**STATE OF HAWAII  
DEPARTMENT OF TRANSPORTATION**

**ADDENDUM NO. 2**

**KEKAULIKE AVENUE EMERGENCY REPAIRS  
AT MILE POST 8.2  
DISTRICT OF MAKAWAO  
ISLAND OF MAUI  
FEDERAL-AID PROJECT NO. ER-25(001)**

**January 25, 2024**

MASH FLEAT Terminal TL-3 Standard Post System		Sheet:	1
		Date:	04/10/19
Drawing Name: MFLT		By:	JRR
Scale: None		Rev:	0

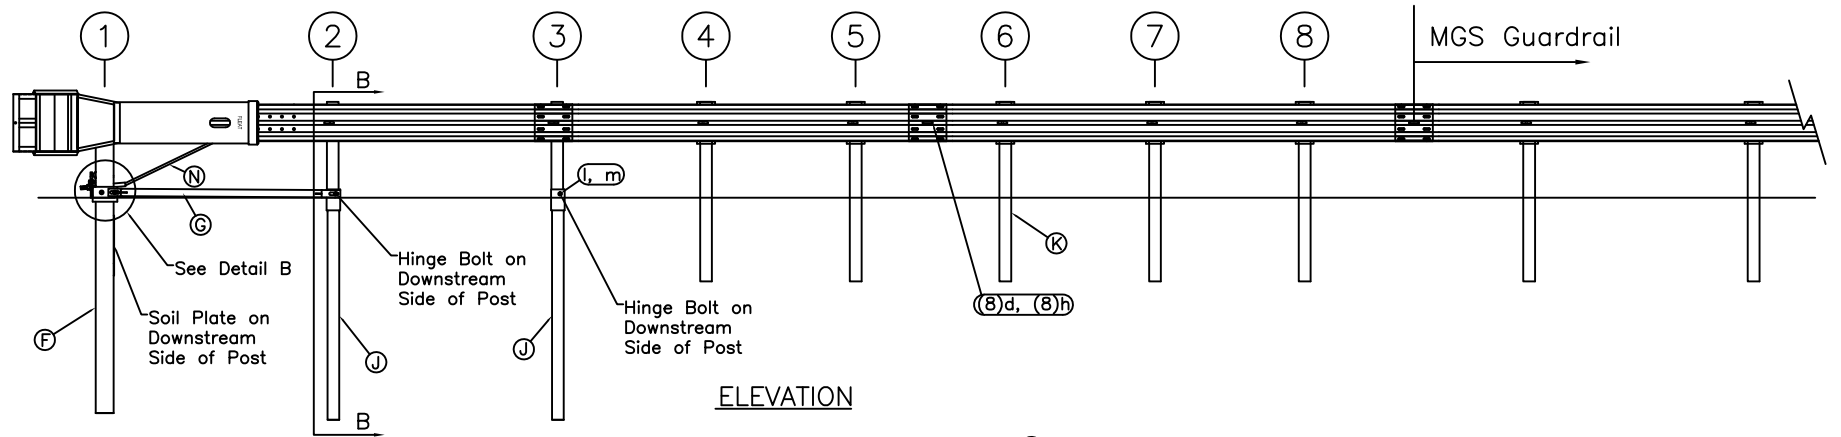
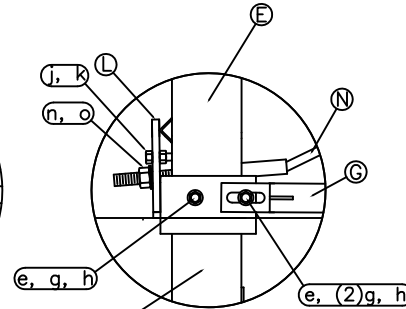
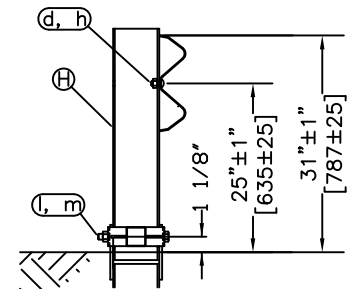
**RFI 8 - What type of Guardrail End Treatment is to be installed at STA 112+91.38? Please provide a bid item for the end treatment in the Proposal Schedule.**

**RFI 8 Response** – The MFLT (TL-3) End Treatment should be installed at Sta. 112+91.38, see attached detail. **BID ITEM 606.0300** has been added to the **PROPOSAL SCHEDULE P-9** dated r01/25/24.
